## Department of Energy

September 27, 2012

## **Waste Treatment and Immobilization Project Response to the Defense Nuclear Facilities Safety DNFSB Concerns: Electrical Distribution System**

Example of Single-line for UPS power to large motors with Active Filter Connected.

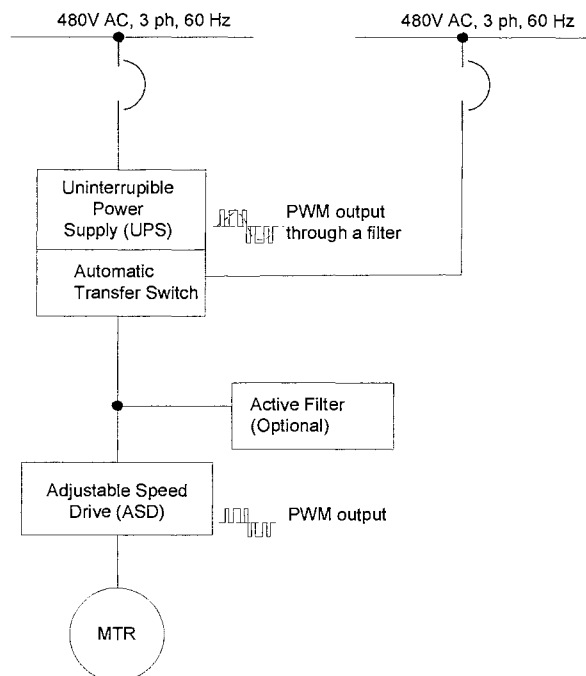
- c) DNFSB Key Point: The WTP project will need to determine the potential voltage fluctuations and harmonics inflicted on ASDs due to switching to and operating on power from UPS systems, and the effects on the ASDs and the driven motor's performance. The project team will have to evaluate the potential for these phenomena to impact system reliability, and develop and implement requirements for filtering equipment for each UPS, ASD, and motor combination that performs a SS or SC function.

- d) DNFSB Key Point: In these circumstances, the solutions required to address the problem were often expensive, labor intensive, and proprietary.

The illustration shows the application of an active filter to offset harmful harmonics, if they were to occur between the UPS and ASD of a motor circuit.

**Follow-up Action:** The project is already scheduled to develop Harmonic Analyses using ETAP Software to locate any buses which exceed the acceptability criteria defined in IEEE 519. Any buses with excessive harmonics will be evaluated and determined if equipment should be added to reduce harmonics to an acceptable level.

Figure 4-1; Induction Motor Open Circuit Voltage Decay

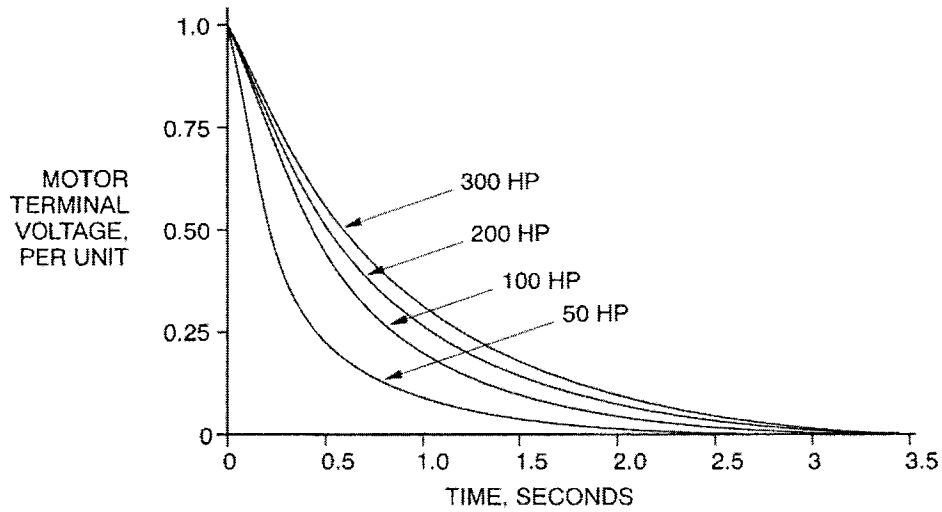
- a) DNFSB Key Point: When the motors are exposed to an automatic bus transfer or fast reclosing of the power supply breaker, there is a potential for the incoming voltage to be out of phase with that induced in the rotating machine. This can result in the development of a transient current and torque, the magnitude of which may range from 2 to 20 times the value rated for the machine, potentially causing damage to the motor.

The Figures on the next page, from two different sources, show that the residual voltage for both (typical) 300 hp and 200 hp motors will decay to 0.25 per unit (volts) in less than 1.5 seconds. Therefore, the 5 seconds listed above is a conservative number. However, the time for residual voltage to decay during fast transfers is not relevant to WTP since non-ASD connected motors will shutdown on loss of power and require manual restart. ASD connected motors, with automatic restart, are designed to catch the (spinning) motors on the fly.

Fast Transfers are not a problem on WTP because the only motors with automatic restart after a loss of power are connected to Adjustable Speed Drives programmed to synchronize to a spinning motor.
